U.S. Army Corps of Engineers Final Environmental Impact Statement for the Savannah River Navigation Maintenance (September 1976)

OPERATION AND MAINTENANCE OF NAVIGATION PROJECT
SAVANNAH RIVER BELOW AUGUSTA
INCLUDING THE NEW SAVANNAH BLUFF LOCK AND DAM
GEORGIA AND SOUTH CAROLINA

U.S. ARMY ENGINEER DISTRICT, SAVANNAH
CORPS OF ENGINEERS
SAVANNAH, GEORGIA
SEPTEMBER 1976

FIGURE C-1
TYPICAL PILE DIKE

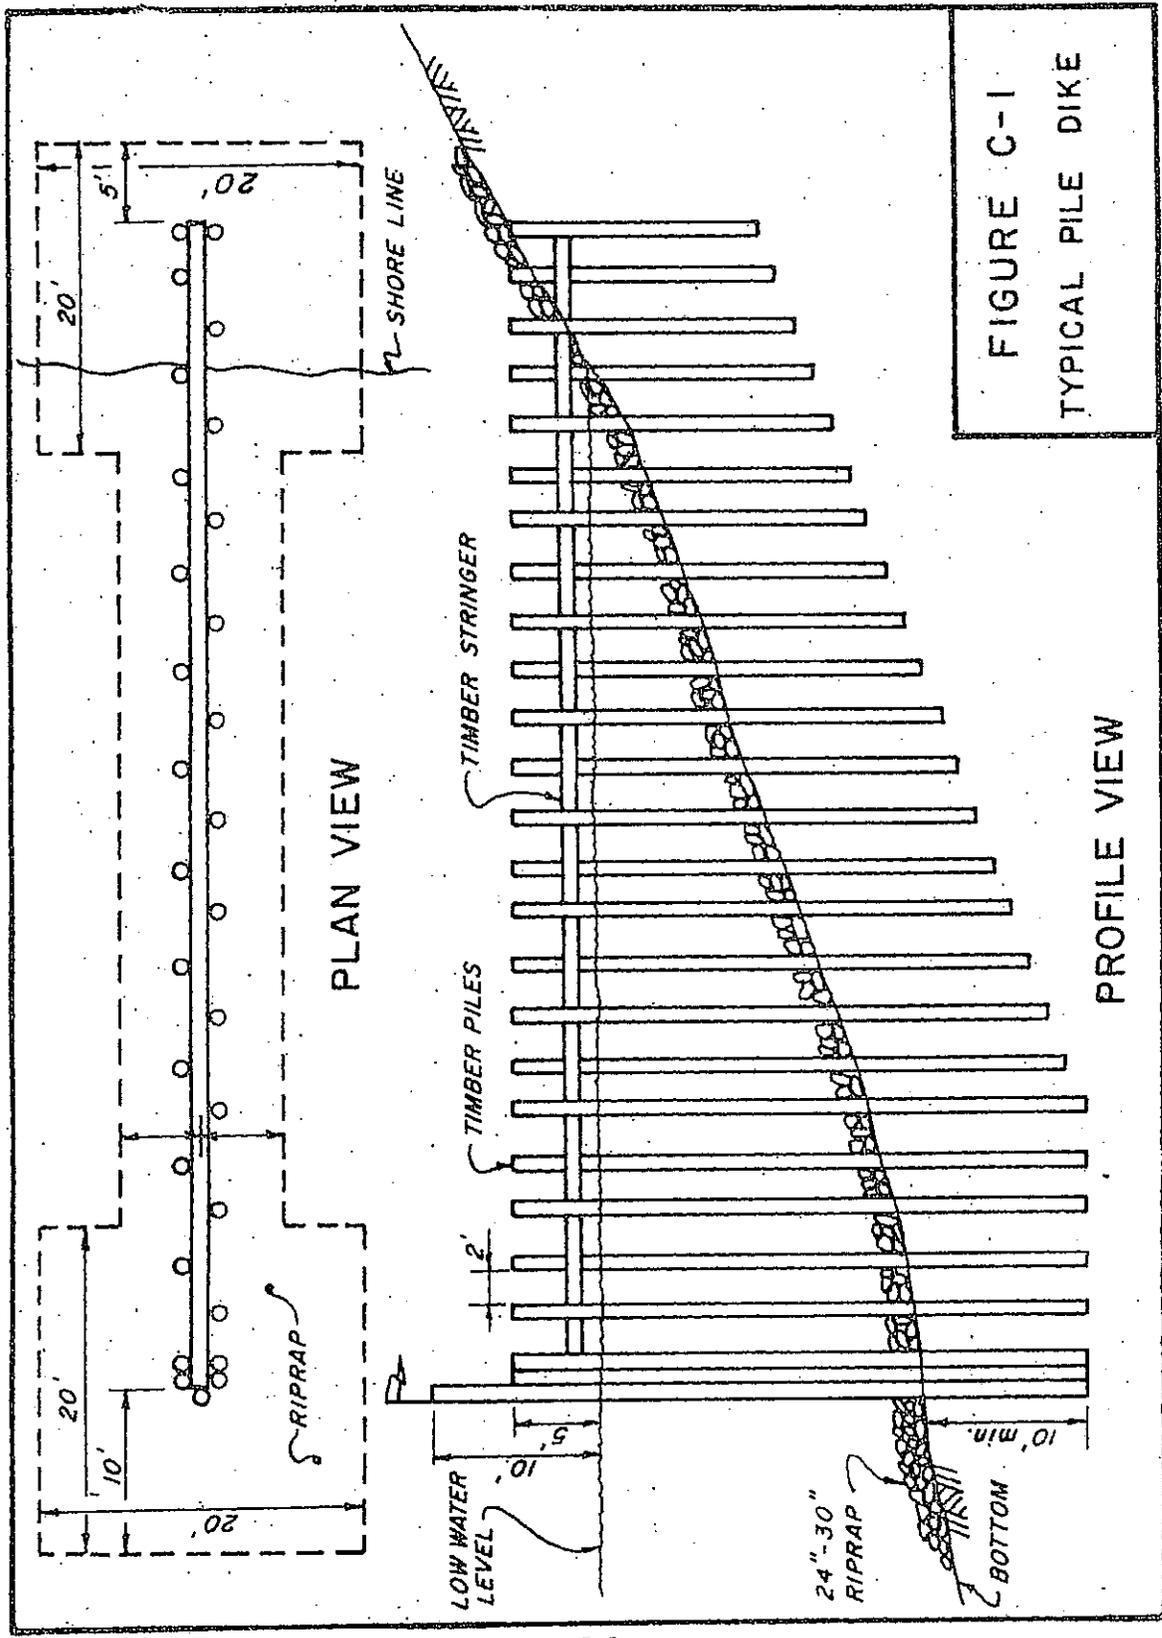
9.73 Comment: Page 1, p. 1.04. We doubt that the general public is aware of what constitutes a pile dike. A detailed description, as well as a schematic diagram, should be provided in the final document.

9.75 Response: Typical illustrations of a pile dike, channel cutoff, revetment and riverbend improvement have been added as Appendix C of the Final Statement.

FIGURE C-2
TYPICAL CHANNEL
CUTOFF

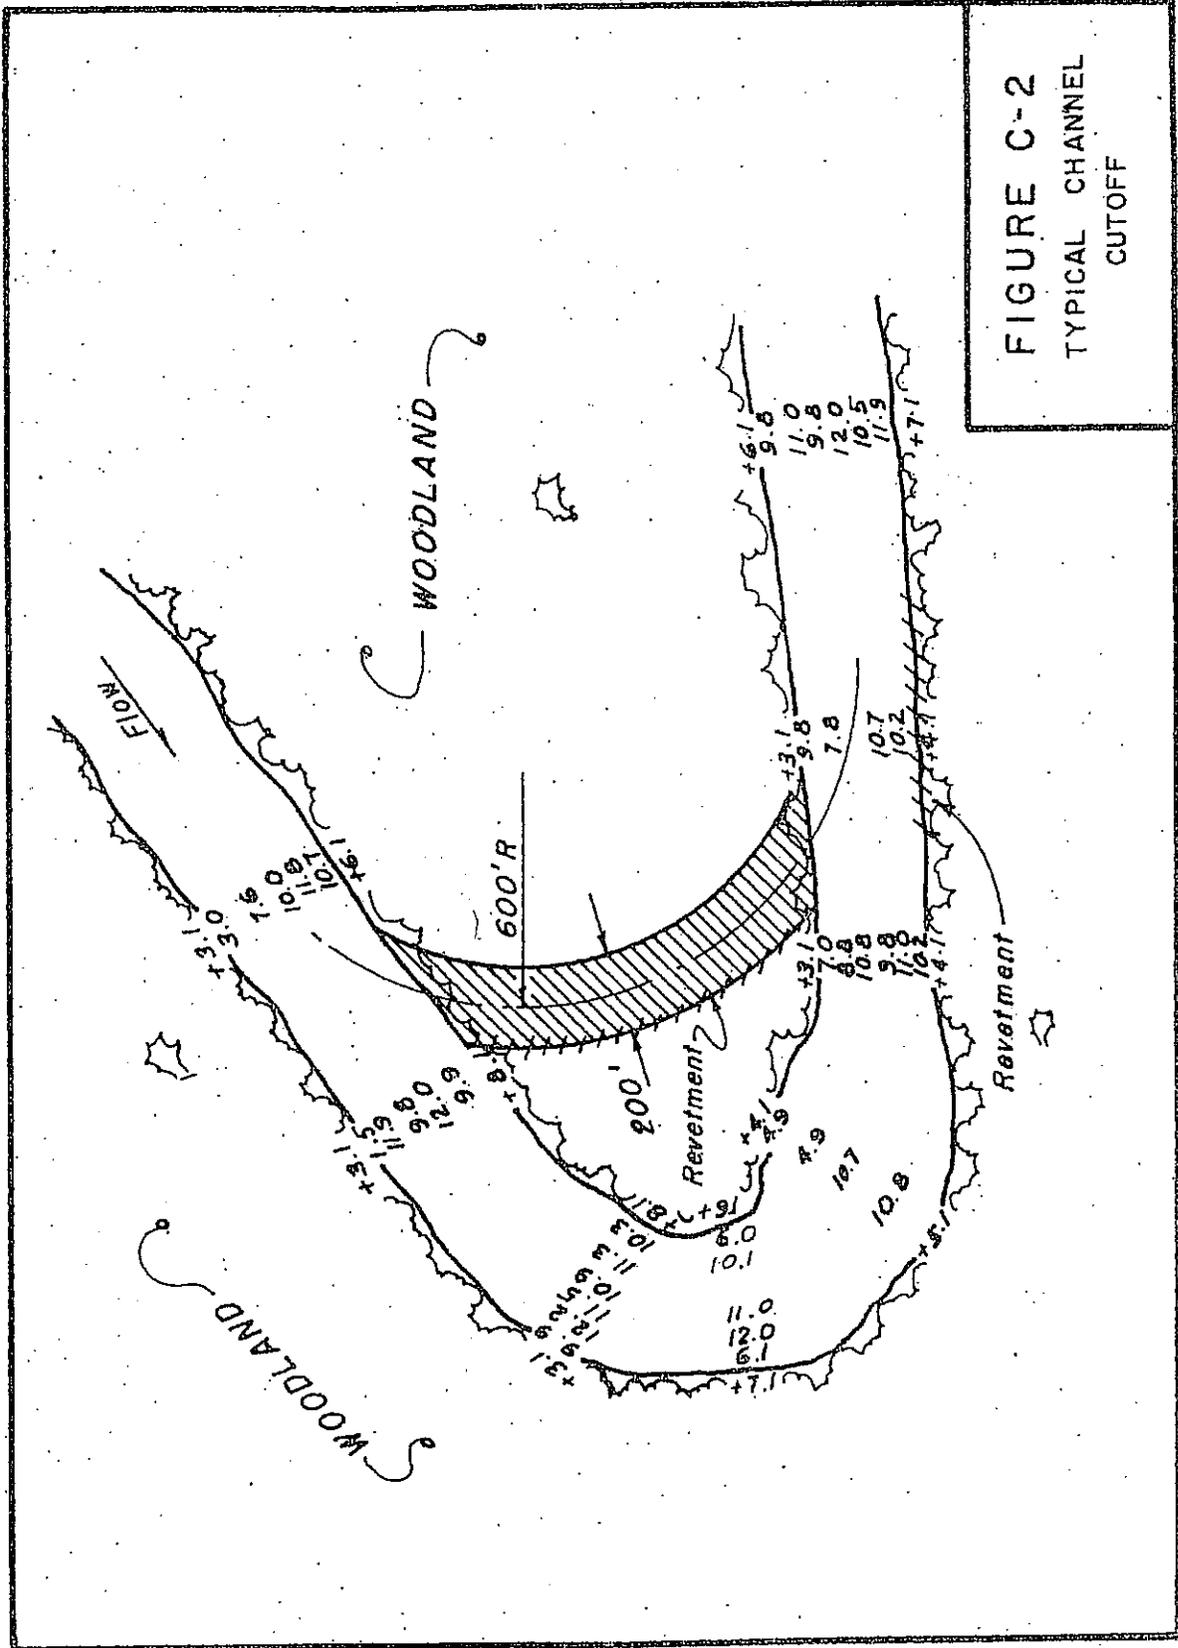
9.35 Comment: The statement does not adequately describe location or extent of proposed river cutoffs, river widening, and the impact of the proposed construction on the associated wetland areas along the river.
